**BRIAN TAYLOR**  
STATE FIRE MARSHAL

The following statements are provided in response to a request for a formal interpretation of section 110.26(C)(2) of the 2020 State Electrical Code. The original request (Appendix A and B) is attached.

Re: **Request for Informal Interpretation of NFPA  
§110.26(C)(2)**

# ROOM 104 EXISTING CONDITION PHOTOS

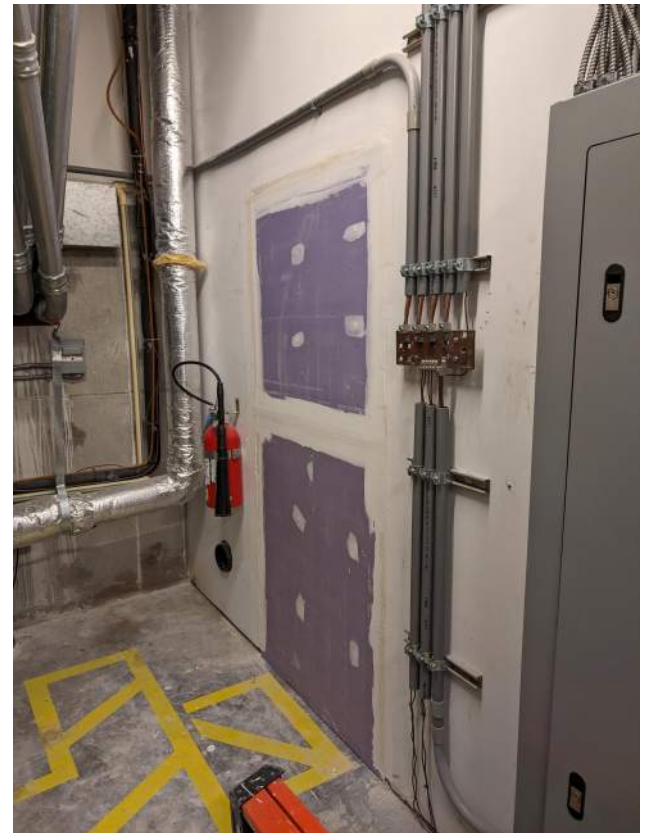
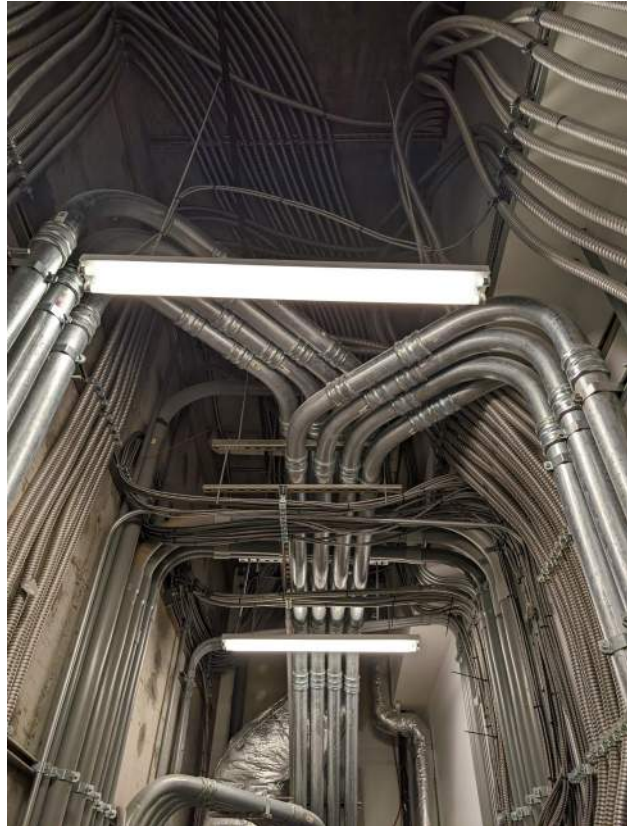
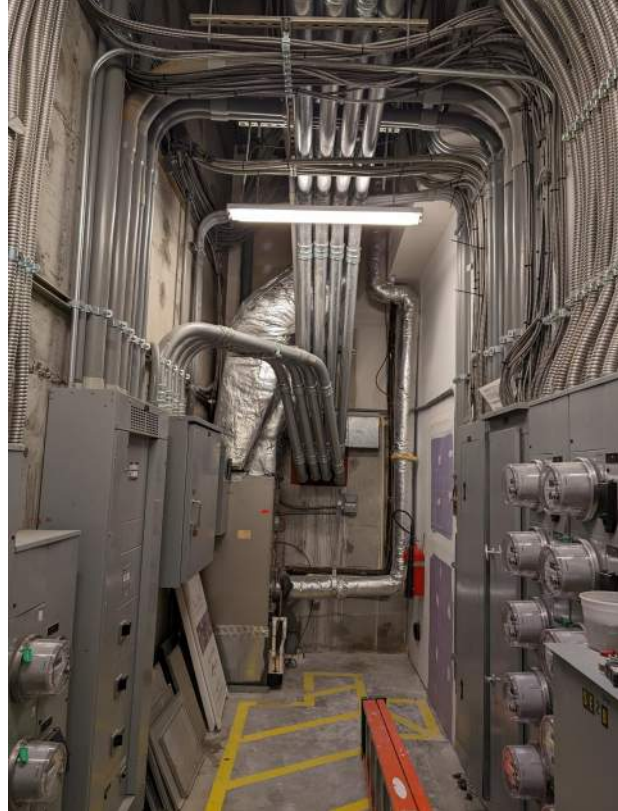
In a corridor style electrical room containing large equipment as described in section 110.26(C)(2) of the 2020 NEC without equipment doors, can the egress to and from the equipment be considered unobstructed in accordance with section 110.26(C)(2)(a) if the working space in front of the equipment is less than twice required in section 110.26(A)(1)? (Example Photos Below)

Technical staff for the NFPA states that the unobstructed egress is not from the electrical equipment itself, rather the egress should be from the working space of the equipment. The State Electrical Division interprets the “working space” in the NFPA’s opinion as the same working space described in section 110.26(A) of the 2020 NEC. Additionally, the NFPA’s opinion with respect working space in this matter is consistent with images and commentary detailed in the NEC Handbooks from 1984 to 2023 editions; images of the 2023 NEC Handbook are reprinted on page 11 of Appendix B in this document. Special attention is given to the last image that displays a similar environment to that of Question 4 except that the theme of the drawing is that providing double working space allows for one entrance. Conversely, the State interprets this image to also represent that if is double working space was not provided in the drawing, two entrances would then be required because the egress is obstructed from one equipment’s workspace into the workspace of the other equipment.

Combining the NFPA’s opinion, the NEC Handbook’s drawings and commentary, and the intent of “unobstructed egress” as interpreted in Answer 3 of this document, the State Electrical Division interprets workspace of additional equipment as an obstruction when determining unobstructed egress from the working space of a single piece of equipment. When determining egress from large equipment, each individual piece of equipment’s working space must be evaluated to determine if the only escape route from such working space passes through another equipment’s working space or any physical building component in order to be deemed unobstructed; otherwise, either the working space must be doubled, or an additional means of egress be provided.

Therefore, the egress in Question 4 is not considered “unobstructed”.
